2012 IOAP Project Modification

IOAP Programmatic Modification Summary

August 17, 2012 (Revised September 20, 2012)

Subject: 13th Street and Rowan Street Storage Basin
Minor Project Modification
IOAP Project No. L_OR_MF_155_M_09B_B_B_4
DOJ Case No. 90-5-1-1-08254

N 13th St and Rowan St Storage Basin

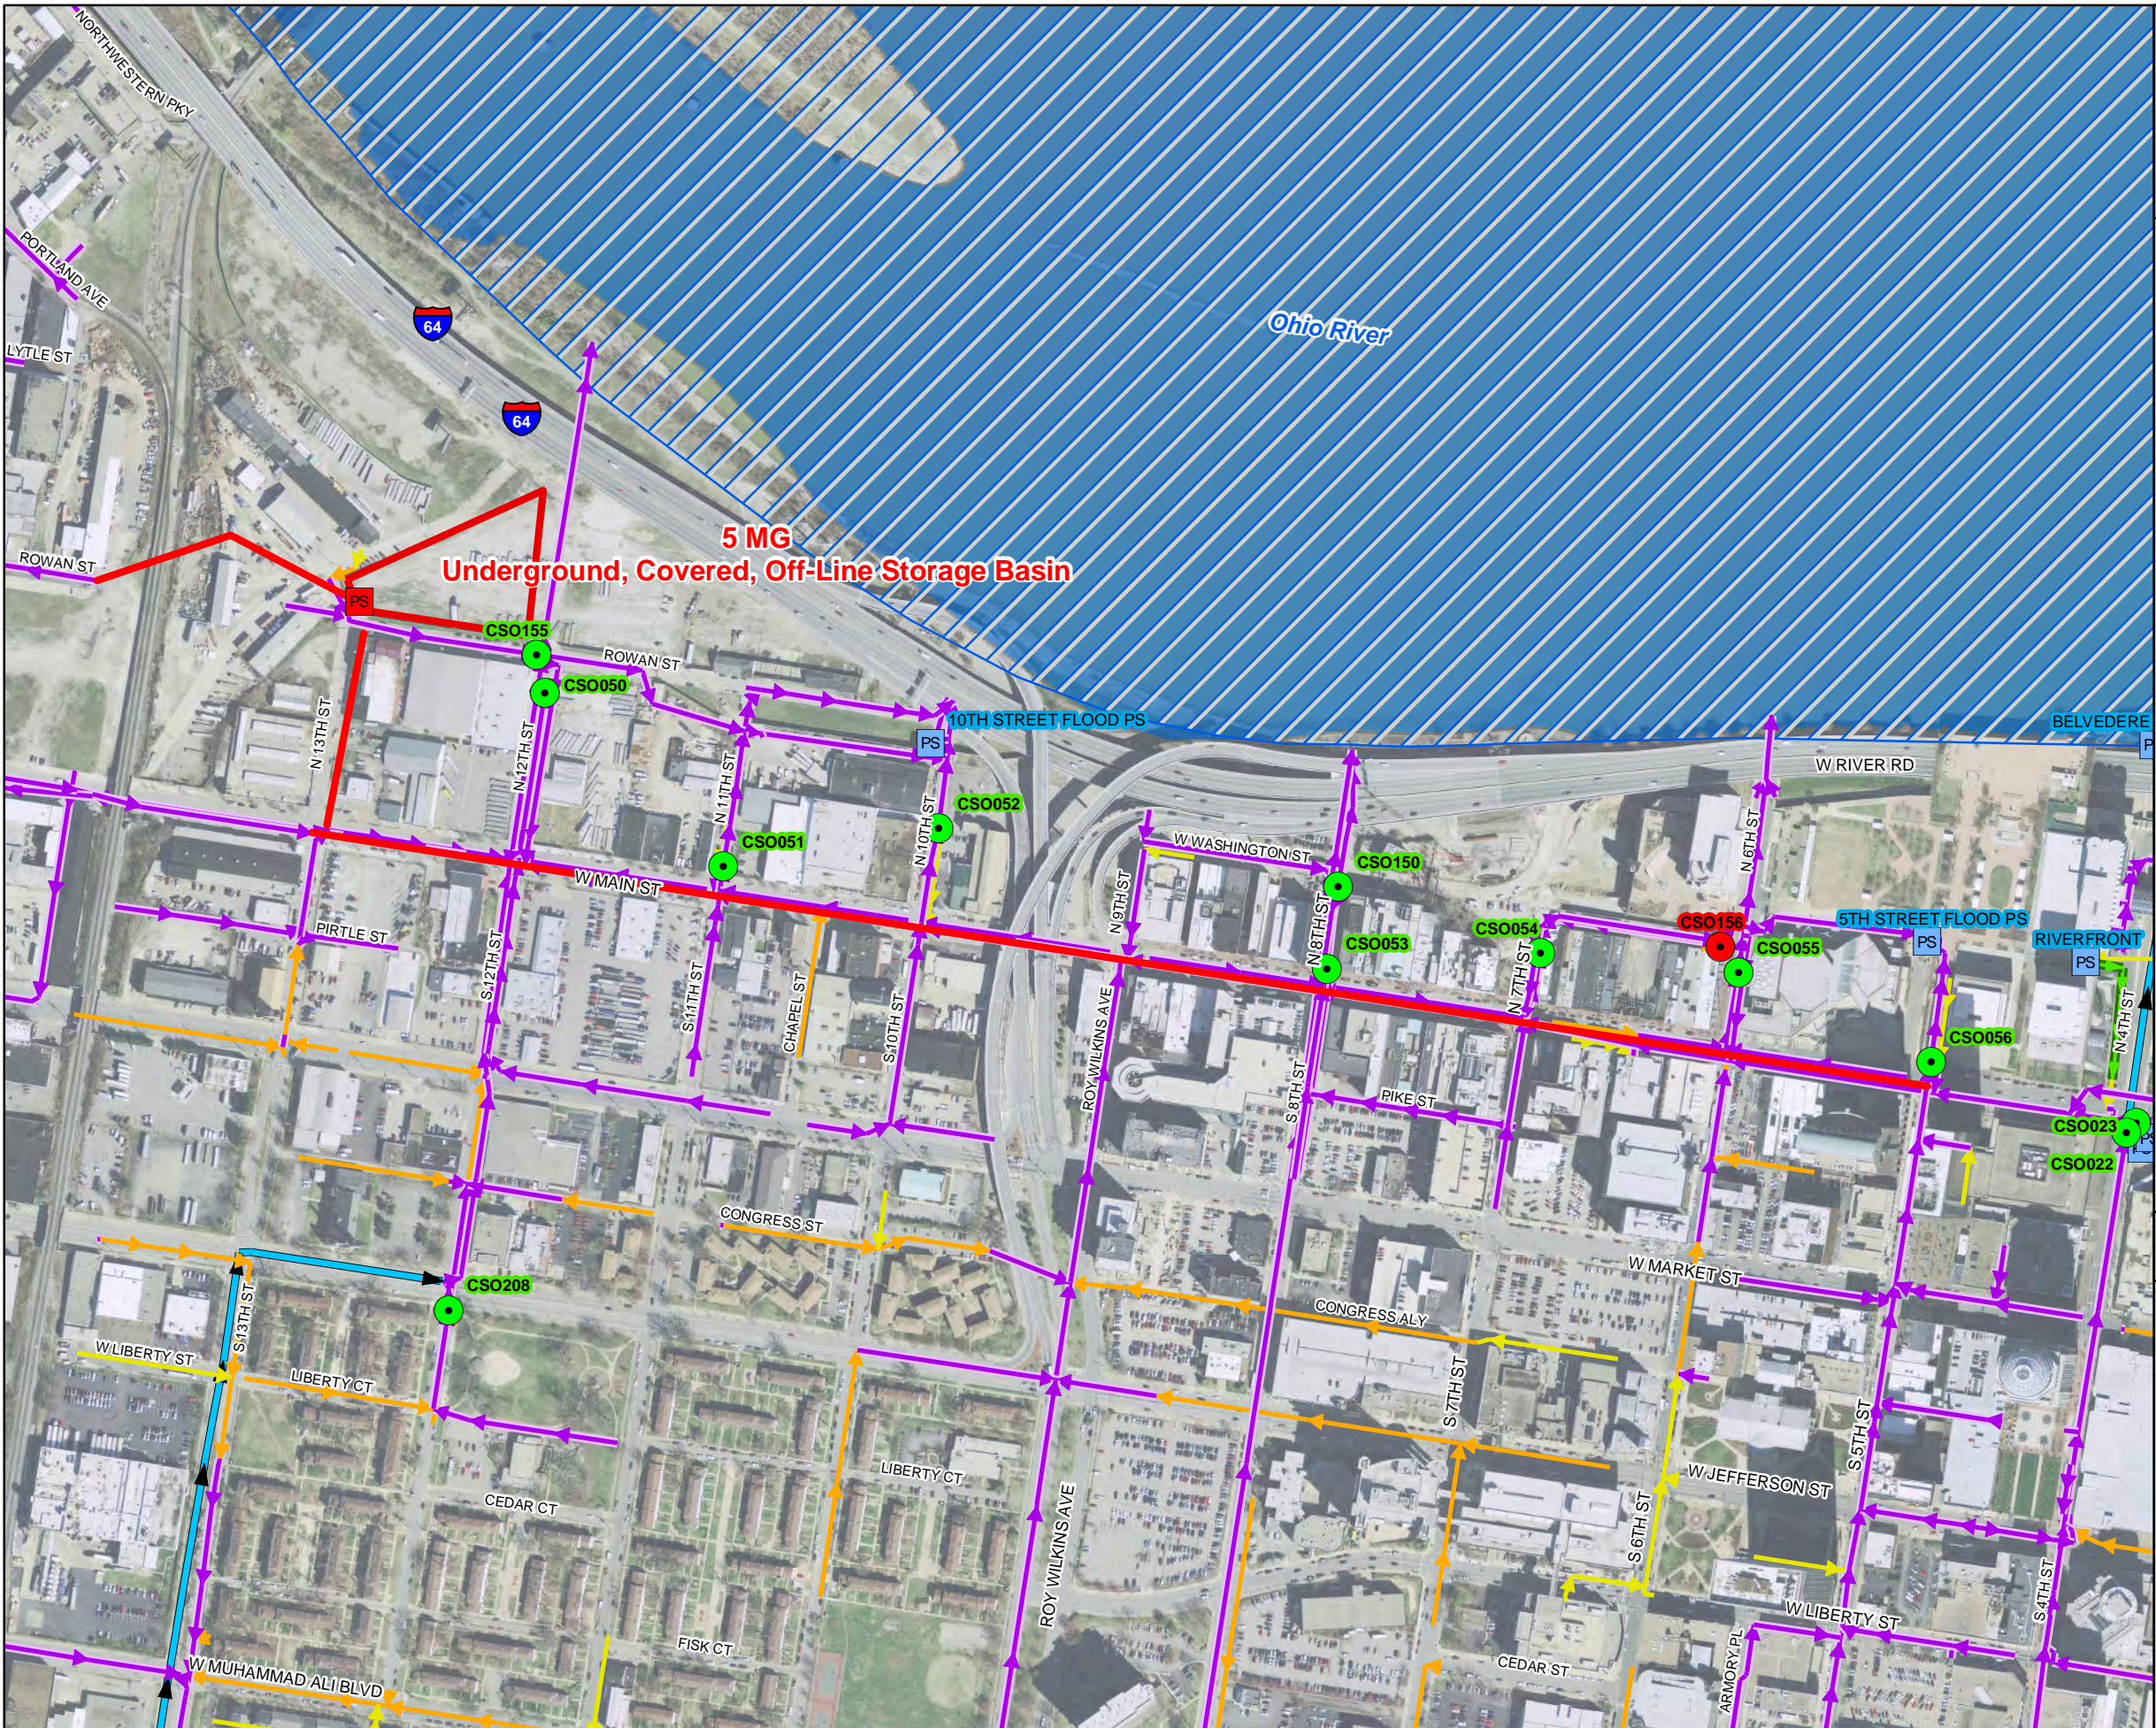
The modifications requested include a change in project approach, size of the storage basin and conveyance as well as the combined sewer overflows (CSOs) to be controlled by the project.

2. Incorporating in-line storage at CSOs 023 and 058 as part of the 13th and Rowan project;
3. Reducing the size of the storage basin from 14.44 million gallons (MG) to 4.36 MG as a result of sewer model re-calibration, splitting out of the aforementioned CSOs and a more detailed understanding of system functionality in this area. While the completion date of the storage basin is proposed to remain the same, some of the new projects for the Central Relief Drain CSOs will have earlier completion dates, thereby accelerating the reduction of CSO control in this area; and
4. Revising the level of control for the CSOs controlled by the storage basin to eight overflows in a typical year due to a revised benefit/cost analysis.

Project Description: This project includes a large conveyance line from multiple CSOs and 4.36 MG underground covered concrete basin to reduce overflows to 8 overflows per typical year. This project also includes weir modification to CSO 023 and 058. Two routes and costs for the conveyance line have been identified. The first route involves micro-tunnelling along Main Street, and the alternate route involves traditional open cut sewer installation along River Road. A right-sizing analysis may be used to potentially reduce the size of the basins or eliminate some of the conveyance lines.

LTCP Project Number: L_OR_MF_211_M_13_B_A_8

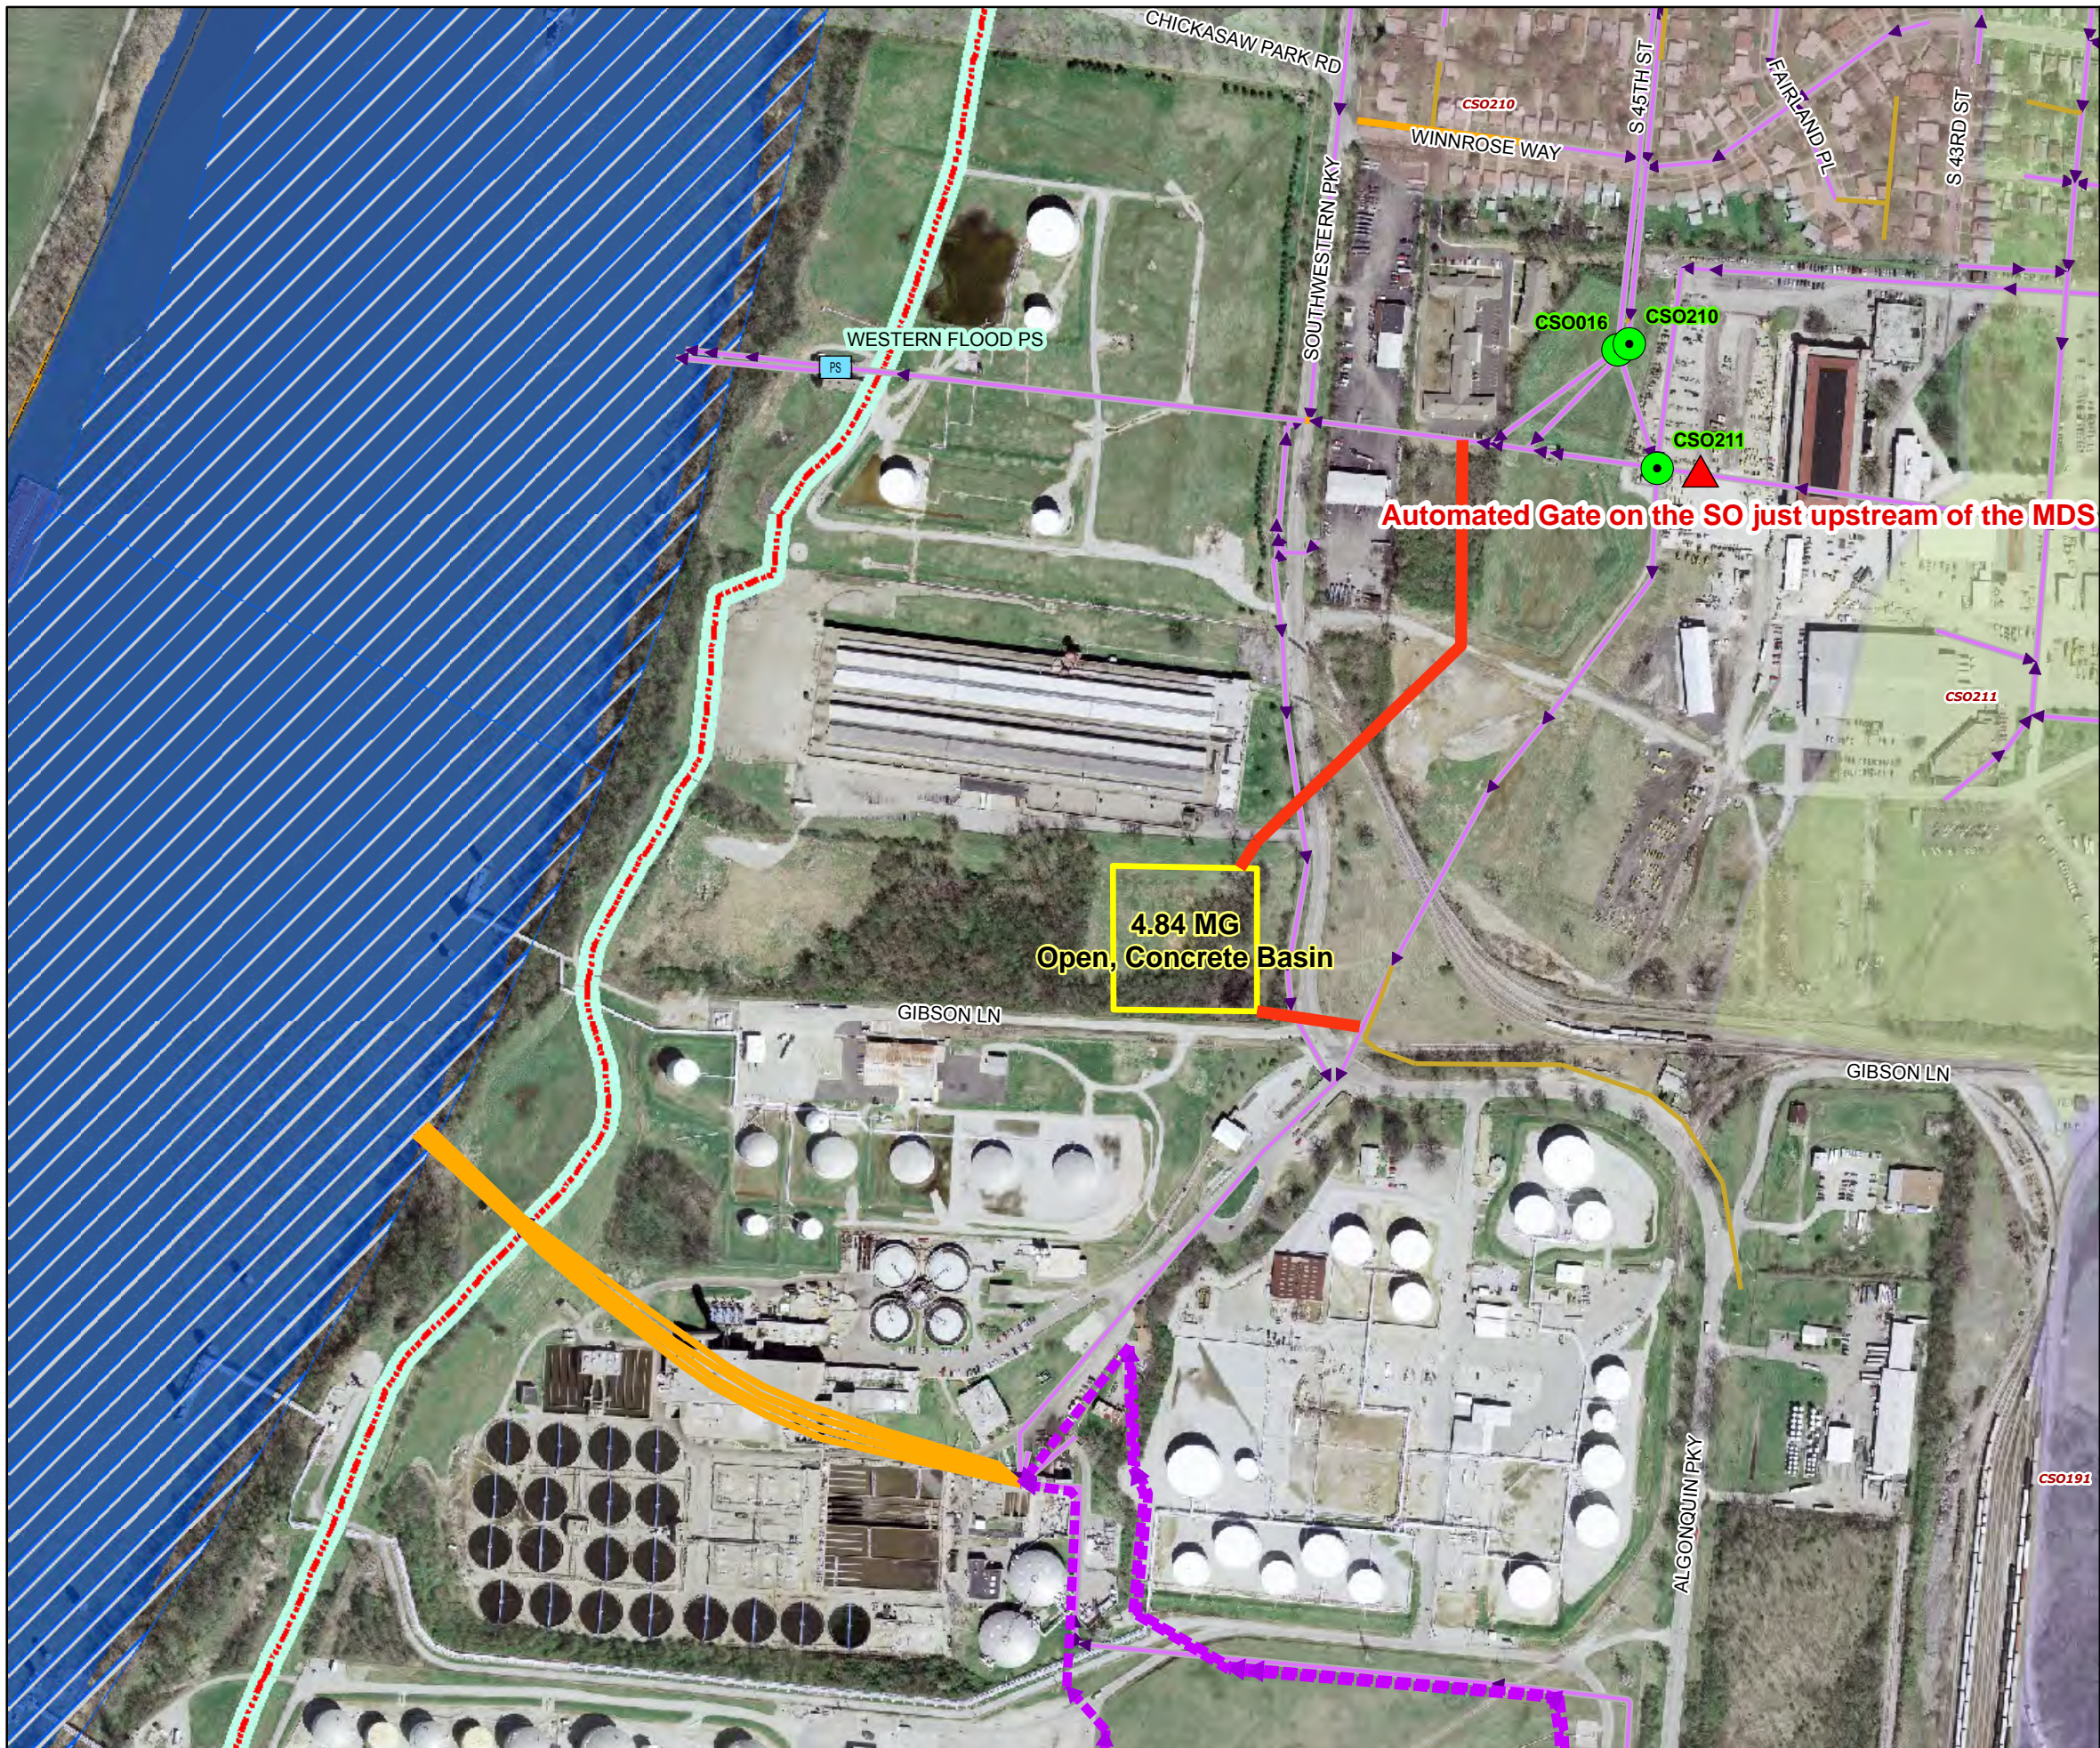
The modifications requested includes the elimination of the 4.84 MG Algonquin Parkway storage basin due to operational strategy revisions at the Morris Forman Water Quality Treatment Center (WQTC) and reduction of pumped flows from the Southwestern Pump Station and increased storage at the planned Paddys Run Wet Weather Treatment Facility. Two new projects have been established to construct two in-line storage facilities in the Southern Outfall that were described in the original project. Project names are the Southern Outfall In-line Storage - 43rd St (SOR1) project and Southern Outfall

As a result of this operational strategy revision, the storage volume needed to control CSOs at the MDS decreased, and the 4.84 MG basin is no longer needed to manage CSOs to the approved level of control. The two in-line storage projects along the Southern Outfall outlined in the original 2009 IOAP, however, are still necessary. The storage volume provided at the Southwestern Pump Station has increased, which is the subject of a separate request for a minor modification to the Paddy's Run Wet Weather Treatment Facility.
